**U.S. NUCLEAR REGULATORY COMMISSION
REGION IV**

Docket Nos.: 50-313; 50-368
License Nos.: DPR-51; NPF-6
Report No.: 50-313/98-01; 50-368/98-01
Licensee: Entergy Operations, Inc.
Facility: Arkansas Nuclear One, Units 1 and 2
Location: Junction of Hwy. 64W and Hwy. 333 South
Russellville, Arkansas
Dates: January 26 to 30, with in office inspection until March 30, 1998
Team Leader: P. Gage, Senior Reactor Inspector, Maintenance Branch
Inspectors: P. Balmain, Operations Engineer, Office of Nuclear Reactor Regulation

Arkansas Nuclear One, Units 1 and 2 NRC Inspection Report 50-313/98-01; 50-368/98-01

AND UNIT 1 INTAKE STRUCTURE

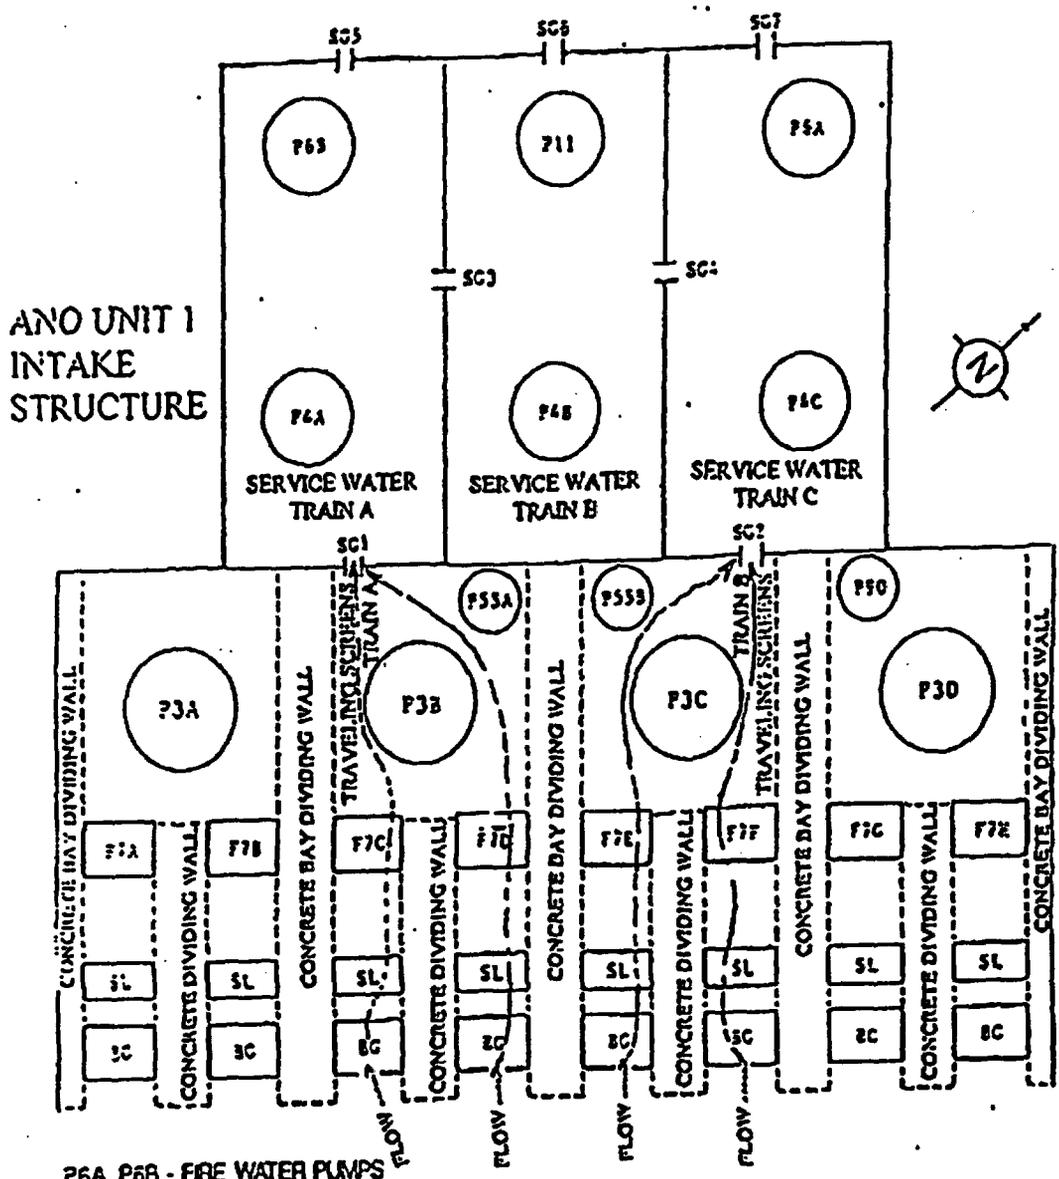
Regarding the traveling screens and screen wash systems, the system engineers provided information that they considered the traveling screens' availability to be tracked under the service water systems. However, since one traveling screen on each unit could provide adequate flow to all the service water loops, any one screen in Unit 2 and any three screens in Unit 1 could be unavailable indefinitely without impacting the availability of the service water loops. Therefore, there was a potential that inadequate performance of the screens could be masked by the overall performance of the service water system.

The team noted that availability was not monitored for some high safety-significant SSCs, specifically, the Unit 2 traveling screens and charging pumps, and the Unit 1 traveling screens. Since availability criteria for these SSCs were not established, balancing reliability and availability could not be achieved. As discussed in Section M1.2, the conditional probability [of success] was used as a performance criteria for some high safety-significant SSCs (e.g., Unit 2 charging pumps). The team questioned the use of the conditional probability [of success] as a performance criteria for balancing reliability and availability because of potential masking of the reliability variable by the availability variable. For example, reliability could increase due to improvements in design or environmental conditions, and availability could decrease due to scheduling more preventive maintenance, which counteracts the effects of increasing reliability in the conditional probability formula. Since the product combination of the

The ANO Unit 1 and Unit 2 design of the intake structure, and the functions that the systems perform, differ significantly. These differences have resulted in some level of dissimilarity between the Unit 1 and Unit 2 Traveling Screen (TS) System Maintenance Rule implementation. For this reason, the response to this question has been addressed separately for Unit 1 and Unit 2. The response for Unit 2 will be discussed first since it is generally more straight forward.

In response to the inspector's concerns, an enhancement was implemented to add performance criteria and monitoring of Unit 1 lake source paths availability. This criteria has been added to the Unit 1 Traveling Screen system and improves availability monitoring of the complete path from the lake to the service water sluice gates. The additional monitoring is beneficial in that any impact to lake availability resulting from traveling screen corrective maintenance, bay outages for zebra mussel cleaning, circulating water pump maintenance, and circulating water bay maintenance activities will be monitored. In addition, monitoring both paths (basically at a train level) results in a criteria is that is more predictive in nature and further ensures that masking and shadowing does not occur. The Traveling Screen system technical basis document and the maintenance rule data base has been updated to reflect the new performance criteria.
